Date March 20, 2021
Revised March 22, 2021
To Sherborn Zoning Board of Appeals
From Thomas C. Houston, PE
Project The Pines Residences and Apple Hill Estates Comprehensive Permit Projects
Subject Stormwater Peer Review

Professional Services Corporation, PC (PSC) reviewed the Stormwater Management Systems and Stormwater Reports for The Pines Residences and Apple Hill Estates Comprehensive Permit Projects (Proposed Projects) on behalf of the Sherborn Zoning Board of Appeals.

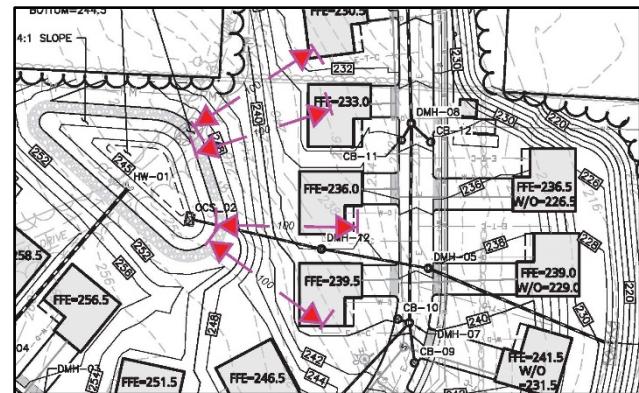
In order to receive credit for TSS removal, the basin must have a sediment forebay complying with the Stormwater Handbook (SWHB V. 2: C. 2: P. 13).

No separate TSS removal credit is given for the sediment forebay but the forebay must be a component of the basin to receive any TSS removal credit.
